# UNITED STATES PATENT AND TRADEMARK OFFICE

APPLICATION NO.	FILING DATE	FIRST NAMED INVENTOR	ATTORNEY DOCKET NO.	CONFIRMATION NO.
10/657,627	09/08/2003	Joon Keun Lee	434/1/004	1539

<b>Office Action Summary</b>	Application No. 10/657,627	Applicant(s) LEE ET AL.	
	Examiner John Hoffmann	Art Unit 1731

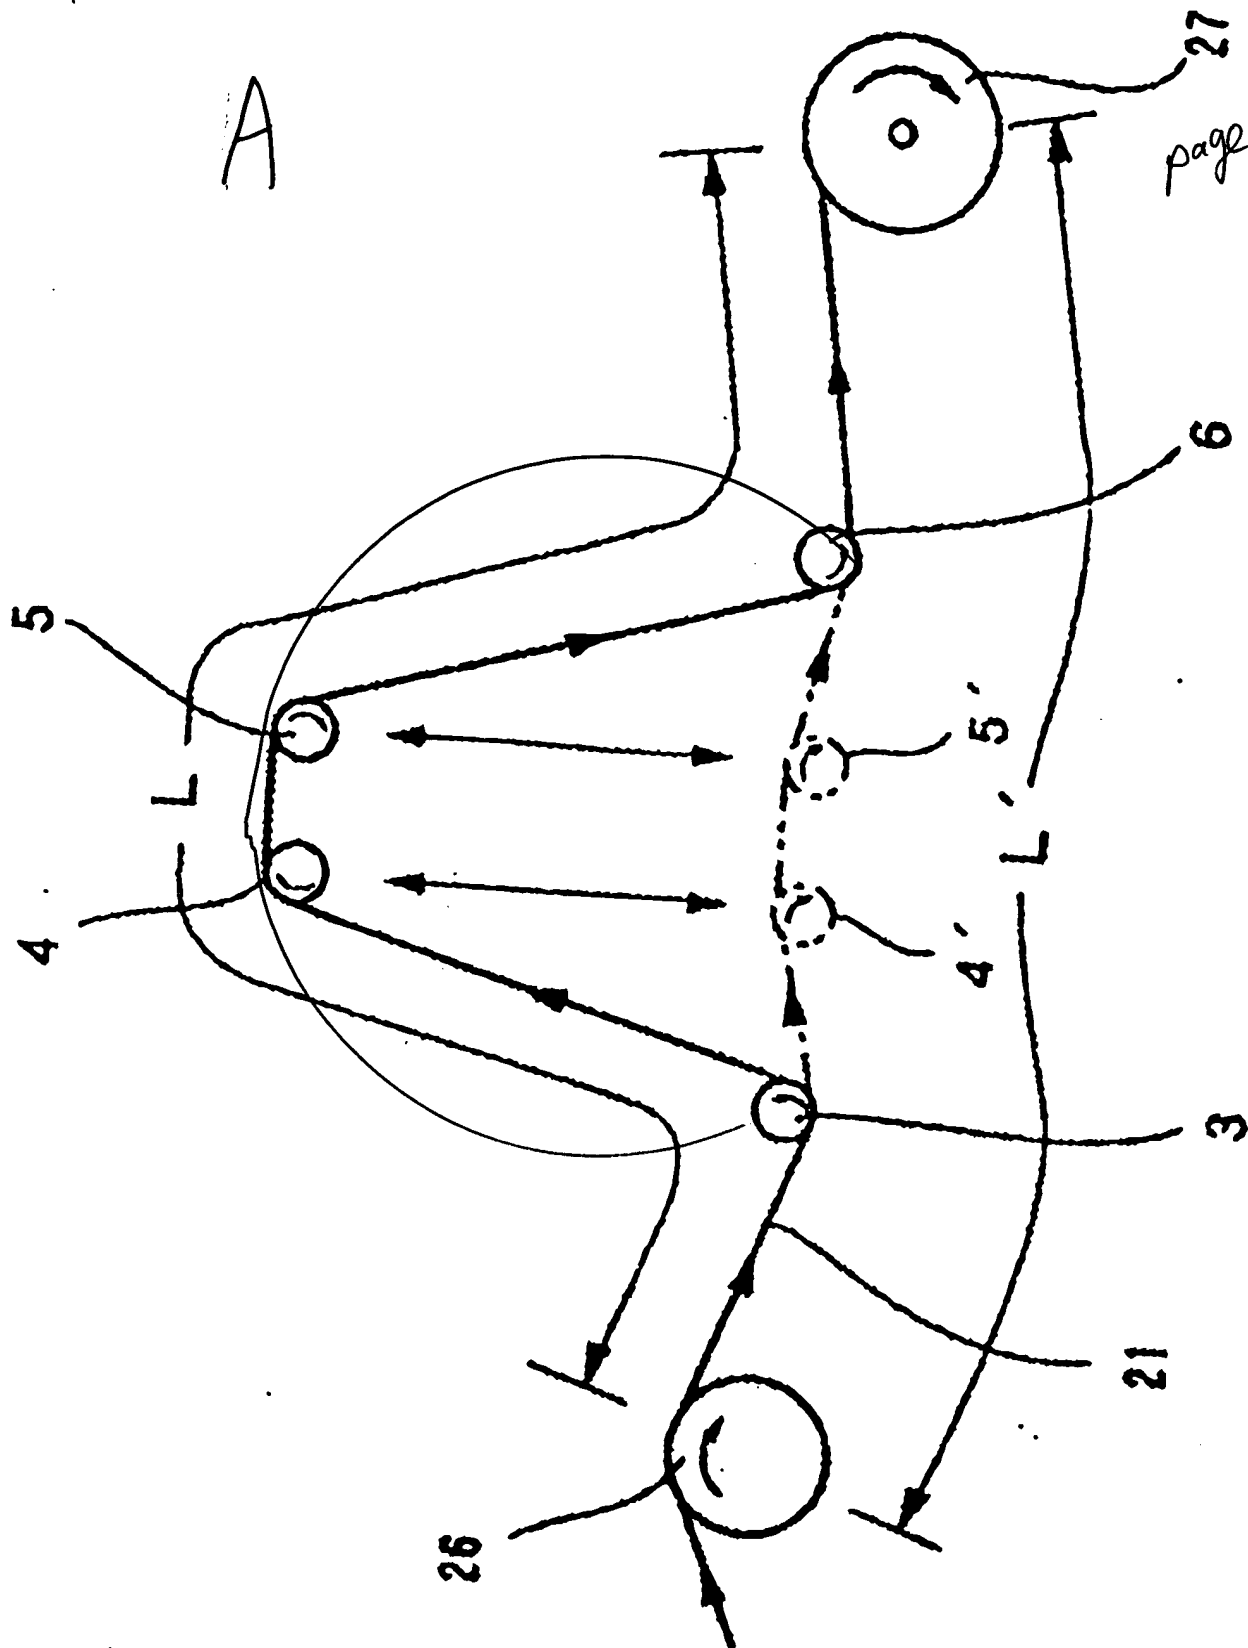
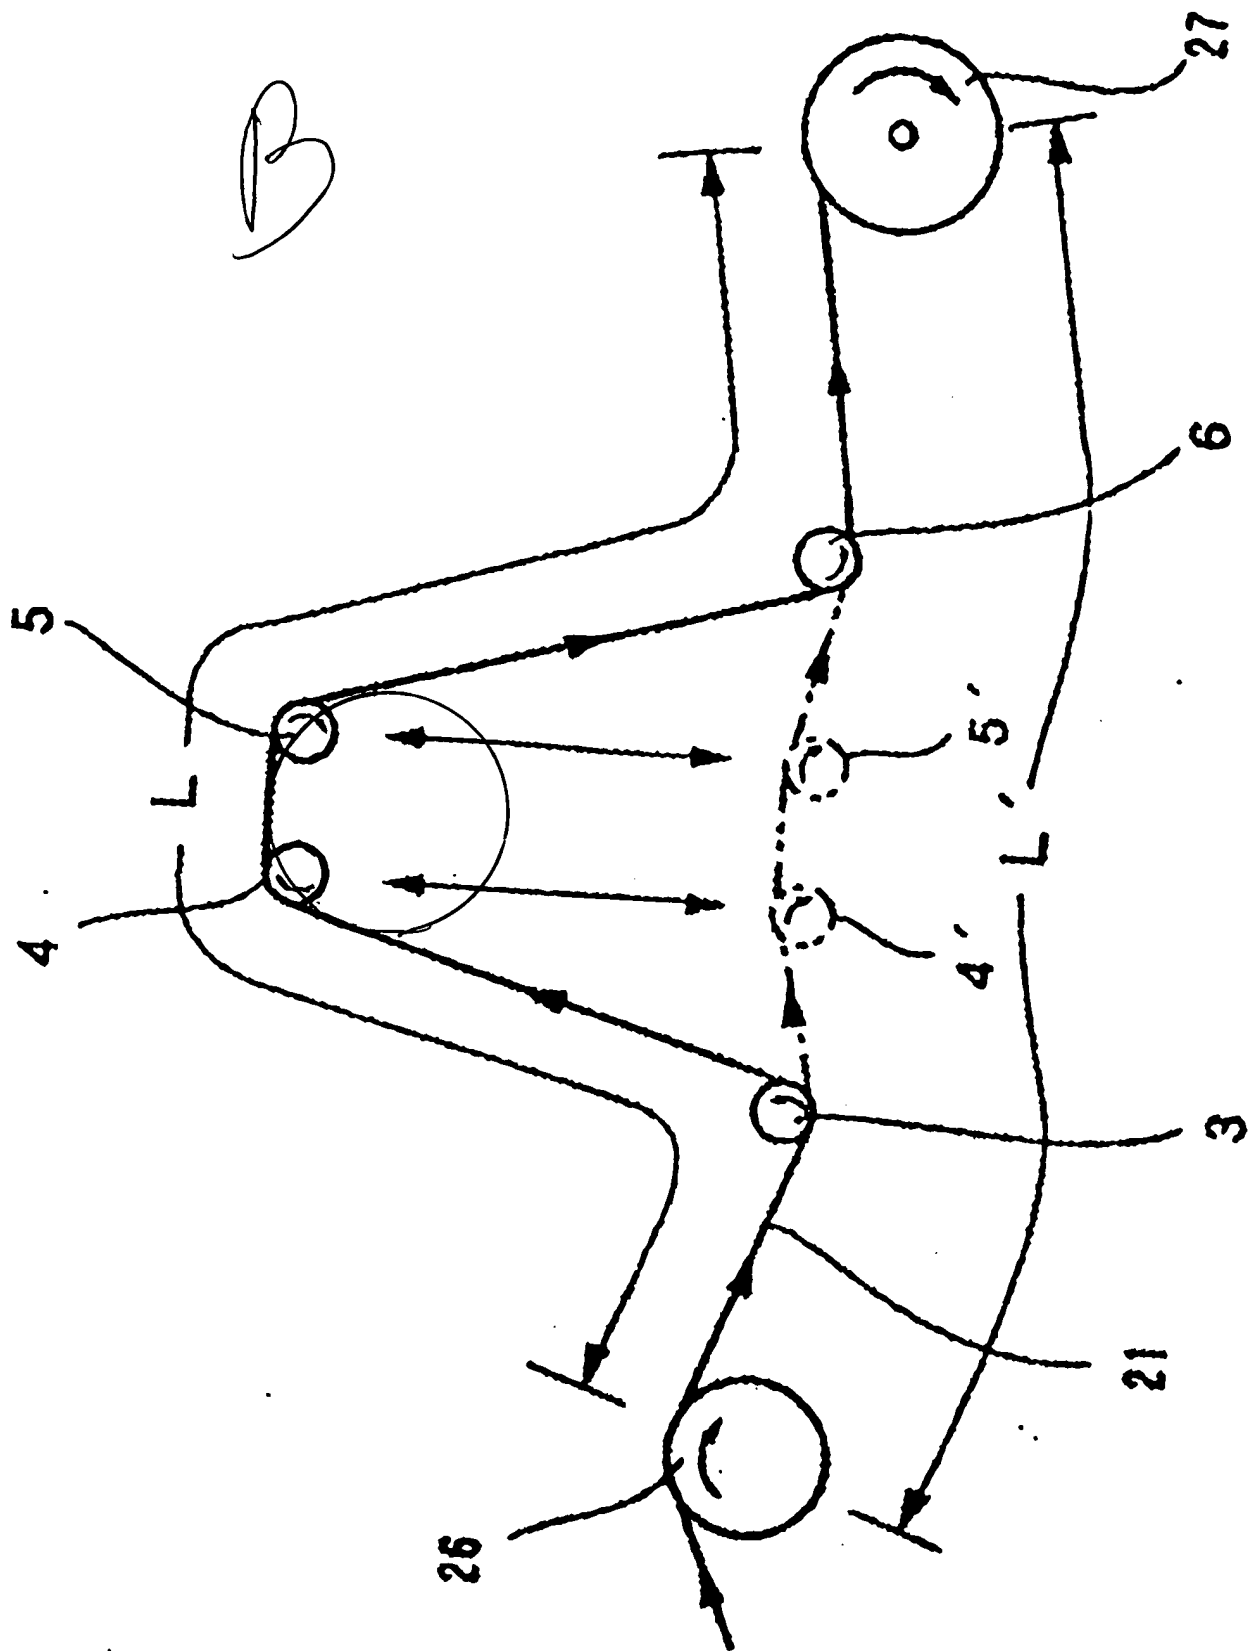
As to the inherent adjustability of the radius: it is noted that the specification does not indicate or suggest how one must/may determine what the curvature radius is of the fiber when the fiber does not follow a true circle. It is clear from Applicant's drawing that Applicant does not intend the claims to exclude non-true circles. It is deemed that the broadest reasonable interpretation of the term "curvature radius" encompasses a radius of a circumscribed circle (see attached figure A), it would also encompass a radius of an inscribed circle (see attached figure B symmetrical path). Examiner could find no reason to interpret the claims as excluding the paths of Yoshida from reading on the present claims. It is clear that Yoshida's invention would meet the limitations relating to the radius – based on this interpretation. In other words: Yoshida is very similar to Applicant's disclose embodiment and examiner can find no basis for concluding that Yoshida's adjustment would not read on the present claims. Any difference would be based on some definition/meaning of the radius: a definition/meaning that Examiner cannot locate.

As to the two "immediately following" limitations – it is deemed that based on Applicant's figure 5 that "immediately following" connotes within the same apparatus – as oppose to reeling the fiber on a spool. Then transporting the spool to another coating apparatus which has the rollers. Specifically see how applicant's fixing roller 17 and the controller unit have intervening structure there between.

As to the release bending stress – it is clear that the bending stress changes to zero after it passes around a roller. In other words, there is a bending stress when the

fiber is bent, and there is no bending stress when the fiber is not bent. The same applies to the concentration.
